**BEFORE THE PUBLIC UTILITY COMMISSION  
OF OREGON**

**LC 67**

In the Matter of PACIFICORP, dba  
PACIFIC POWER's 2017 IRP

Comments of  
Renewable Northwest

**Figure 3—Comparison of CO<sub>2</sub> Emission Forecasts between the 2017 IRP Preferred Portfolio and the 2015 IRP Preferred Portfolio<sup>100</sup>**

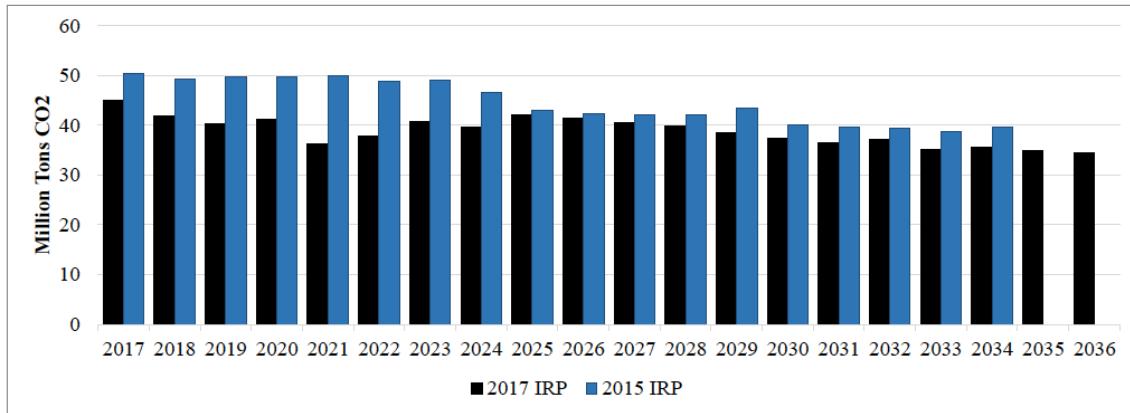
PacifiCorp’s 2017 IRP preferred portfolio minimizes cost and risks while representing a significant improvement in the Company’s expected CO<sub>2</sub>-emissions trajectory. As Figure 3 shows, the Company’s CO<sub>2</sub>-emissions forecast under the 2017 IRP preferred portfolio is lower than under the 2015 IRP preferred portfolio, particularly in the first eight years of the planning period.<sup>98</sup> Indeed, by the end of the planning period, the FS-GW4 would lead to 24.5% less average annual CO<sub>2</sub> emissions than the 2015 IRP preferred portfolio.<sup>99</sup> Renewable Northwest celebrates this downward shift in the Company’s CO<sub>2</sub> emissions trajectory.

**Figure 4—Projected Energy Mix with Preferred Portfolio Resources (2017 IRP)<sup>102</sup>**

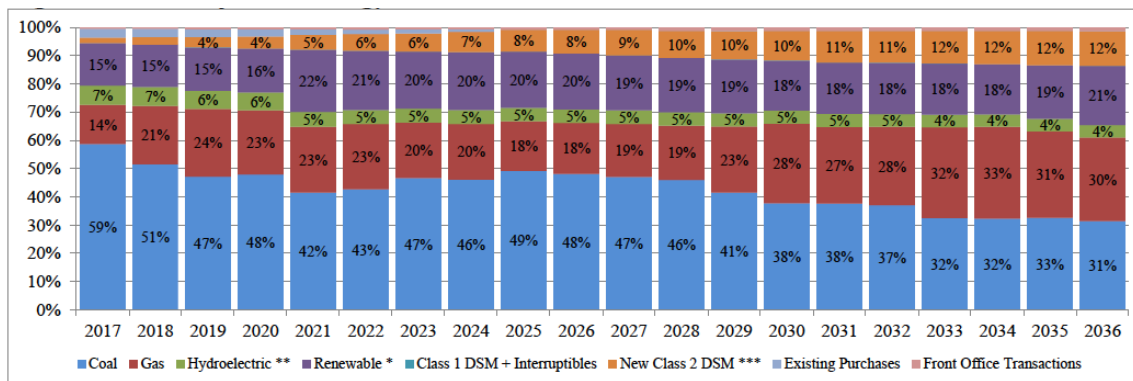
However, the dominant role of fossil-fueled resources in PacifiCorp’s resource mix shows that the Company’s transition toward cleaner resources still has some way to go. As Figure 4 shows, fossil-fueled generation would represent over 60% of the Company’s projected energy mix throughout the planning period, with coal representing between 40% and 50% during the first 12 years.<sup>101</sup>

However, it is worth comparing PacifiCorp’s projected energy mix from this IRP, shown in Figure 4, with the projected energy mix from the 2015 IRP, shown in Figure 5. It can be seen how the 2017 IRP preferred portfolio has significantly less coal energy than was the case in the 2015 IRP (blue bar), with the difference being made up primarily by renewable energy (purple bar) and gas (red bar). Renewable Northwest welcomes this shift to cleaner and less carbon intensive energy production.

Figure 6—Projected Capacity Mix with Preferred Portfolio Resources (2017 IRP)<sup>105</sup>

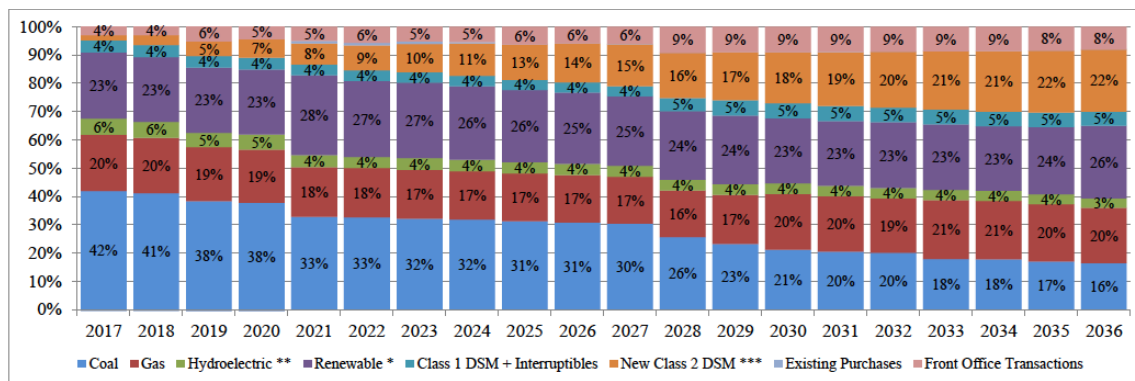
Fossil-fueled resources also play a significant role in the Company’s projected capacity mix. As Figure 6 shows, coal-fueled resources represent over 30% of the Company’s projected capacity mix for the first 10 years of the planning period.<sup>104</sup> However, when compared to the projected capacity mix from the 2015 IRP, as can be seen in Figure 7, both coal (blue bar) and gas (red bar) have decreased in PacifiCorp’s 2017 IRP capacity mix, while renewable energy (purple bar) and new class 2 demand side management (“DSM”)/energy efficiency have increased. Renewable Northwest welcomes this shift to cleaner capacity and more energy efficiency.
